## ORIGINATION FORM

Proposed Revisions to a Standard Plans Index  
(Please provide all information — Incomplete forms will be returned)

Index Number: 654-001  
Sheet Number (s): 1 of 1  
Index Title: Rectangular Rapid Flashing Beacon Assembly

DETAIL "A"

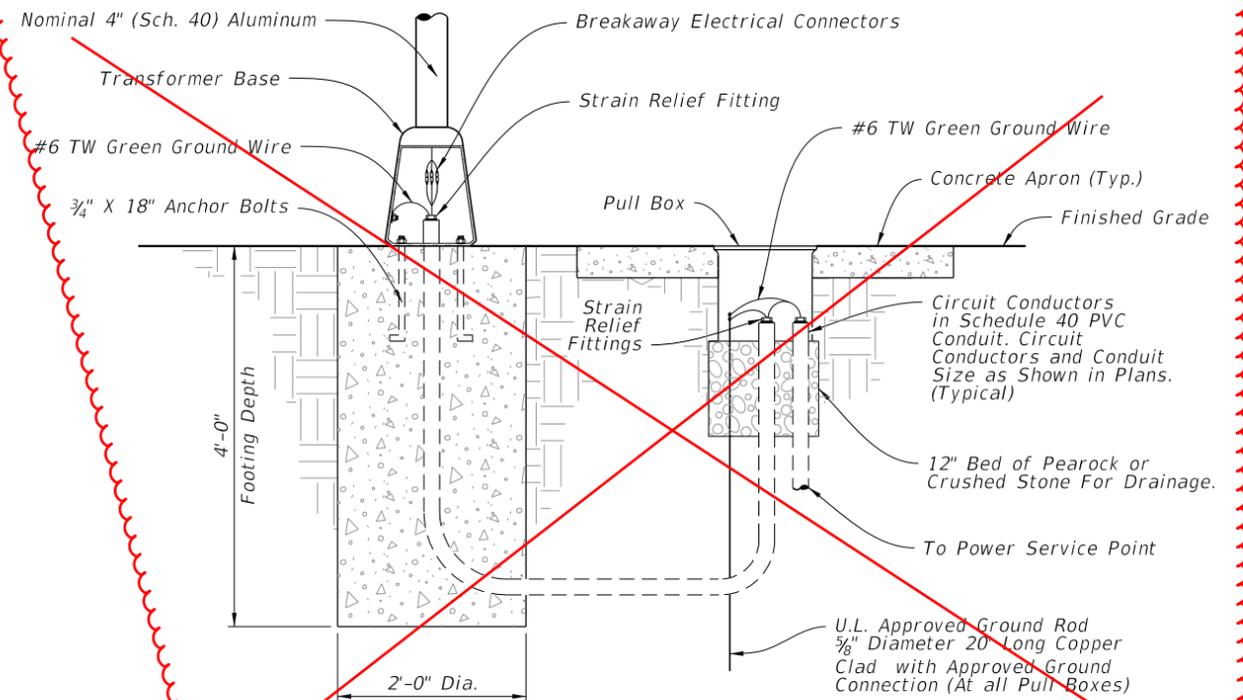
**REORGANIZED SHEET TO SHOW BEACON ASSEMBLY ADJACENT TO SIDEWALK**

POLE WIRING AND FOOTING DETAIL

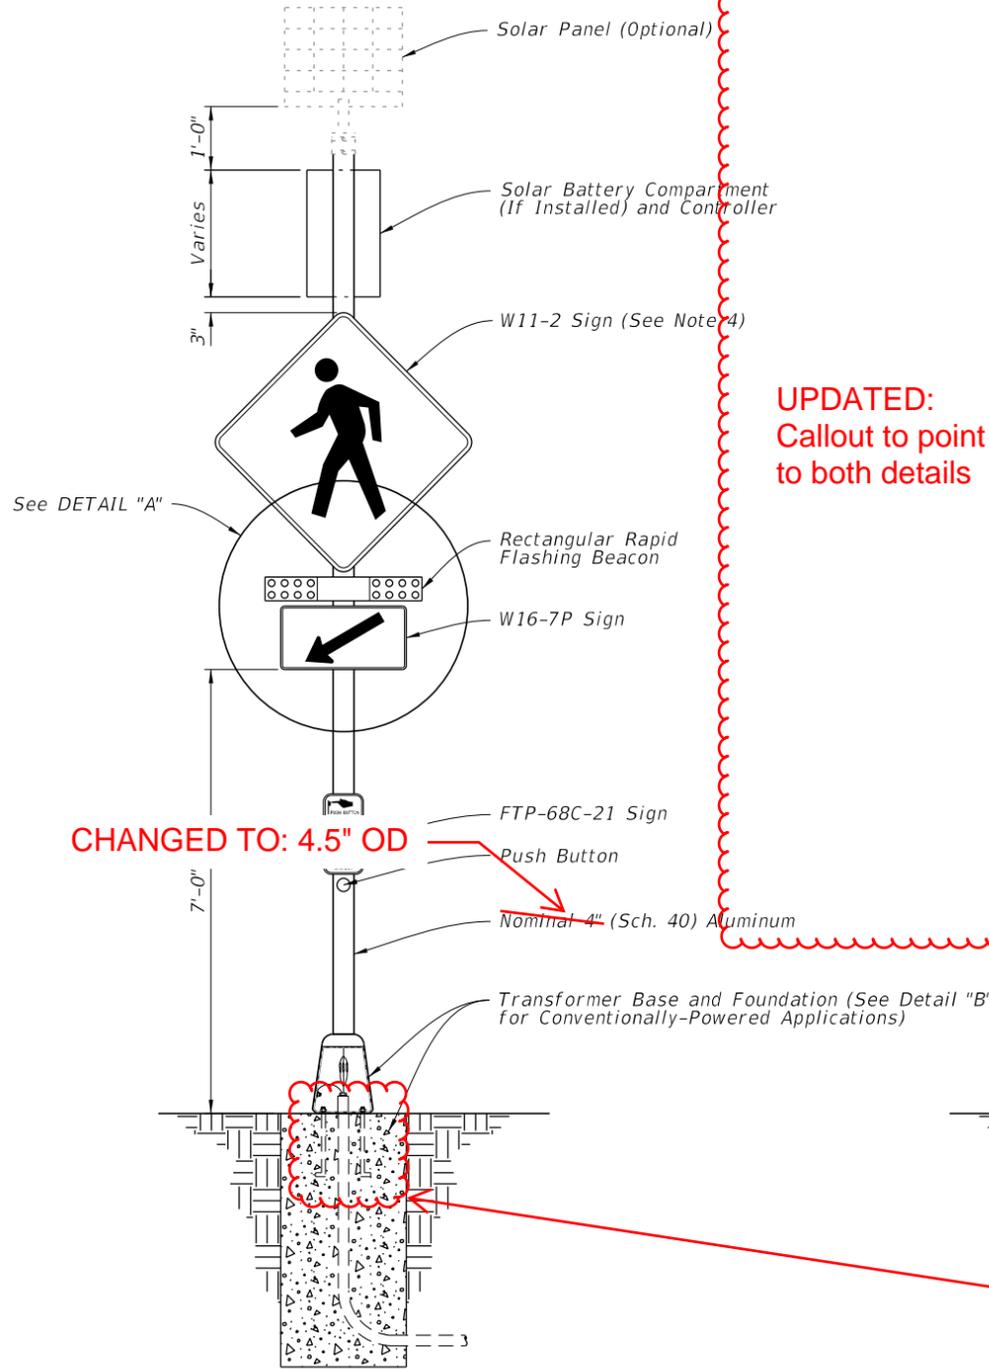
**DELETED DETAIL "B" AND ADDED REFERENCE TO INDEX 700-120 NOTE 1.**

SIDE VIEW

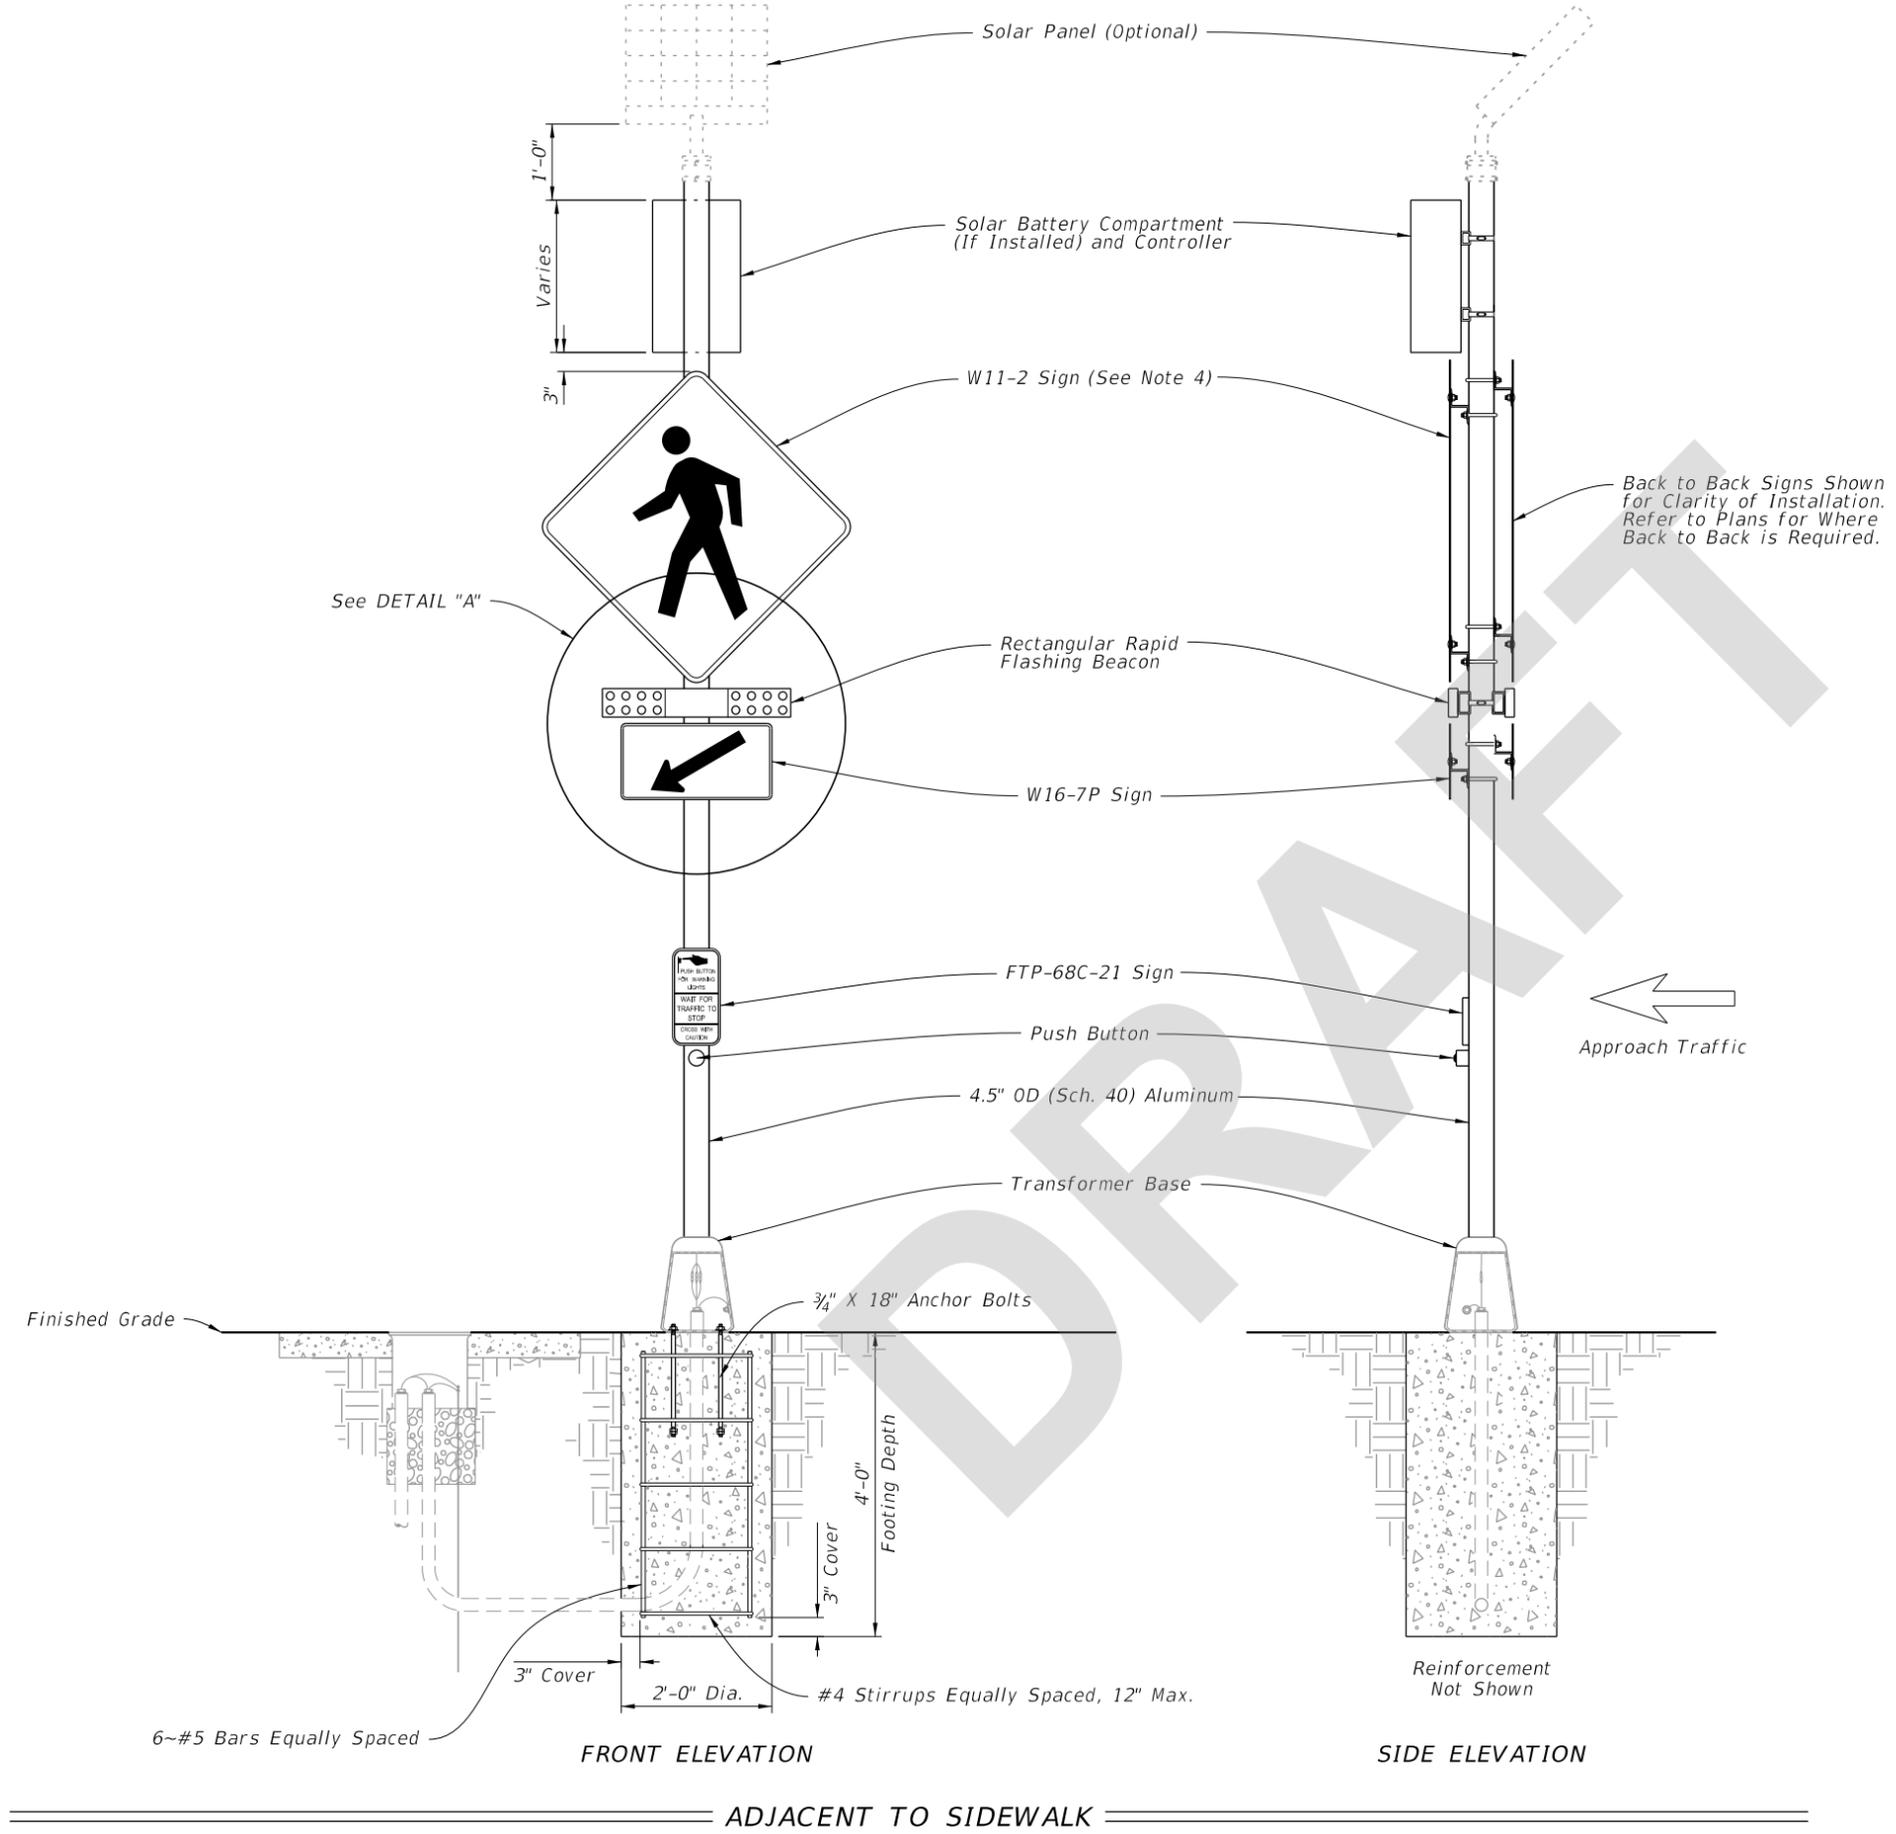
**UPDATED: Callout to point to both details**

**UPDATED: Anchor Bolts**

IN SIDEWALK CURB      SECTION A-A

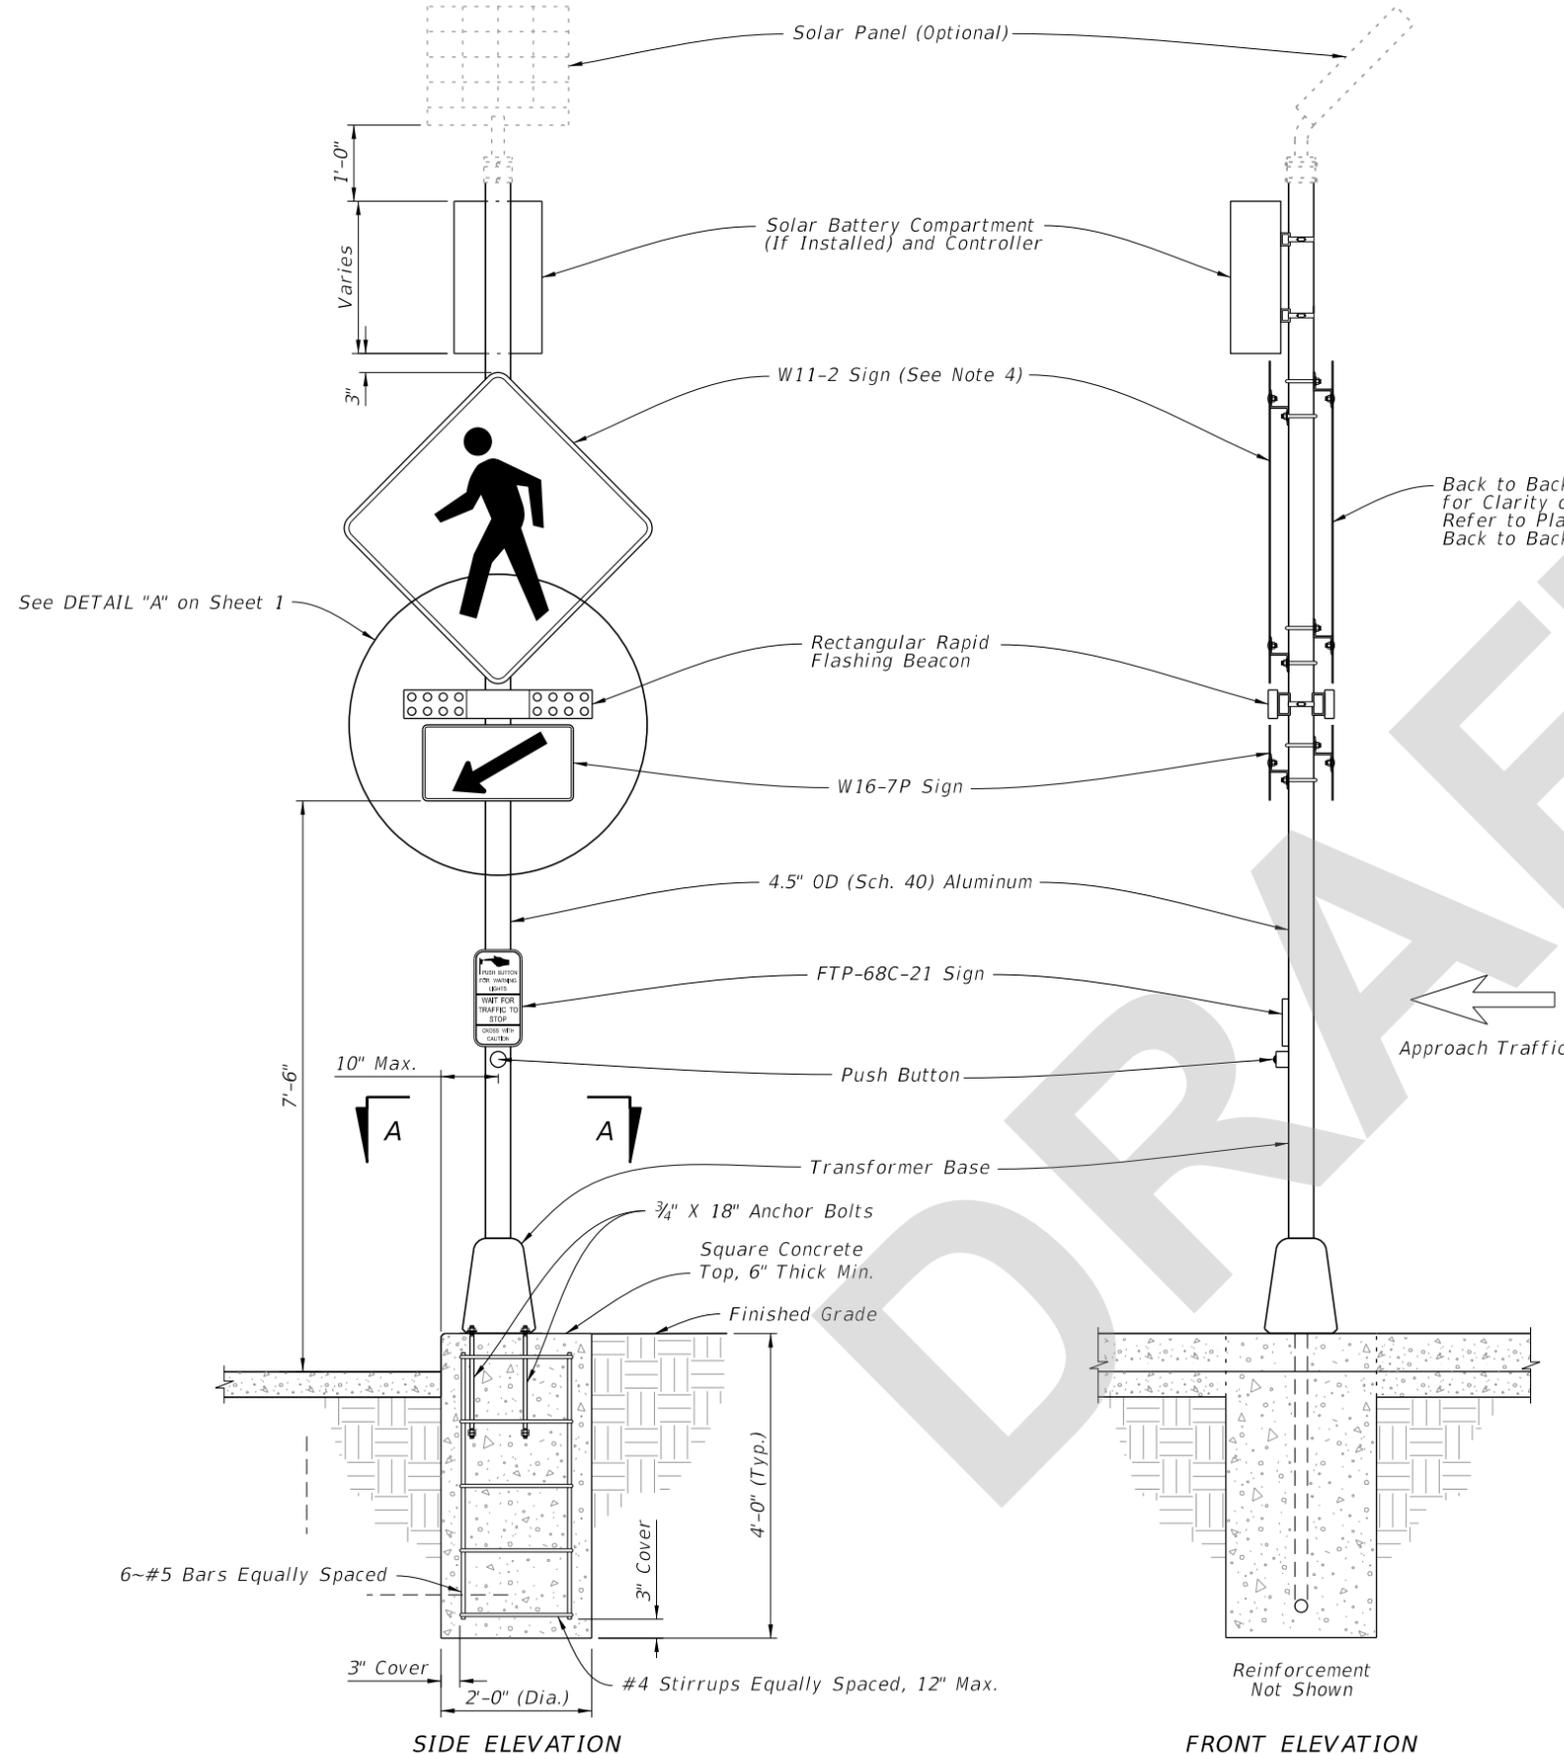
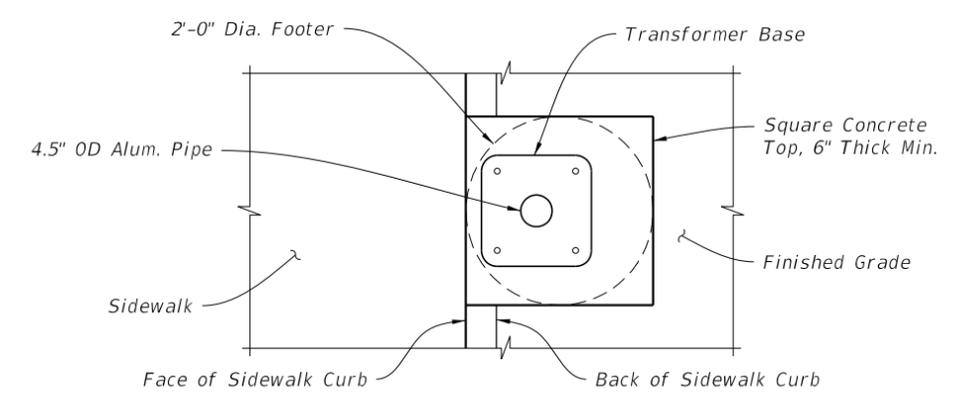
# NEW SHEET

SHOWING BEACON ASSEMBLY IN SIDEWALK CURB
